FOR PERCOLATION TESTING AND SITE EVALUATION

Re: **Perc Testing Plan Submittal**
7081 Pindell School Road

Percolation Test Report; 7081 Pindell School Road, Fulton, MD 20759

APPLICATION FOR VARIANCE
TO COMAR ONSITE WATER/SEWER FOR MDE APPROVAL

Attachment: Percolation Test Field Notes

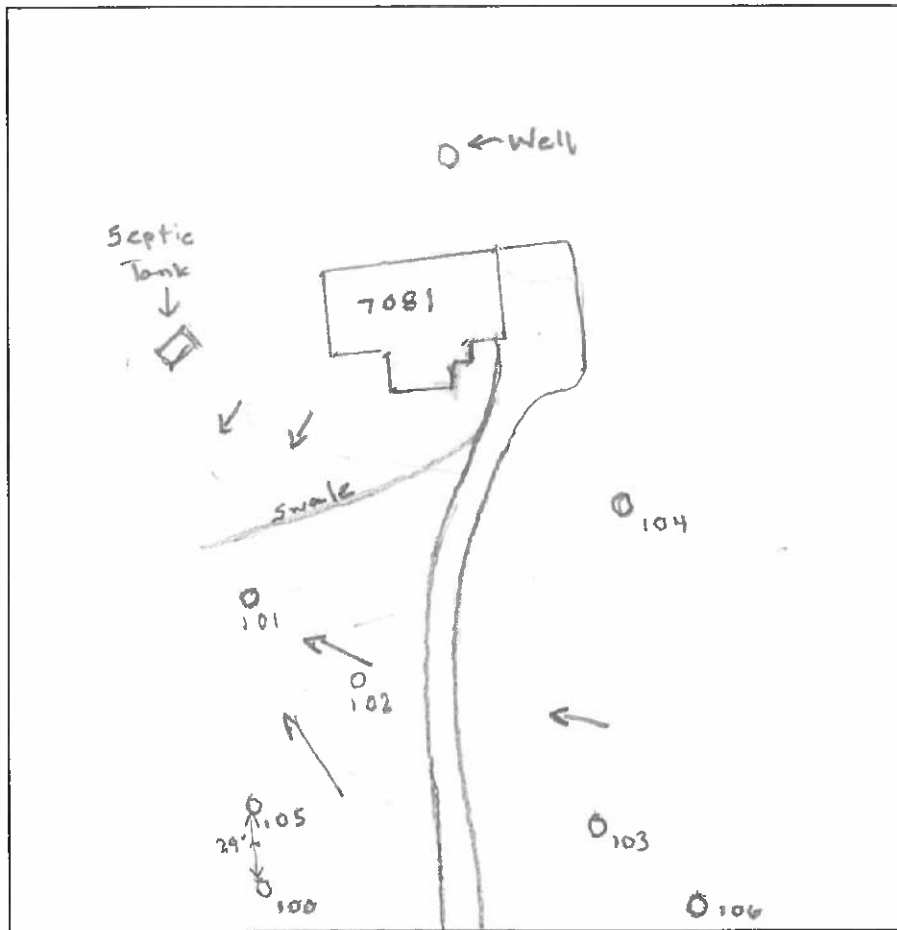
REMARKS Added test holes 105 & 106. Test hole #100 failed. See profile
Sams Creek
 SANITARIAN Mark Oswald BACKHOE Joe / Dave OTHERS Mr. Mays - Hooper
Jim w/ JNM Engineering
 TEST HOLES USED IN SDA _____ AVG. PERC TIME _____ SQ. FT/BR _____
 TRENCH WIDTH _____ INLET DEPTH _____ MAX. BOT DEPTH _____ EFFECTIVE S/W _____
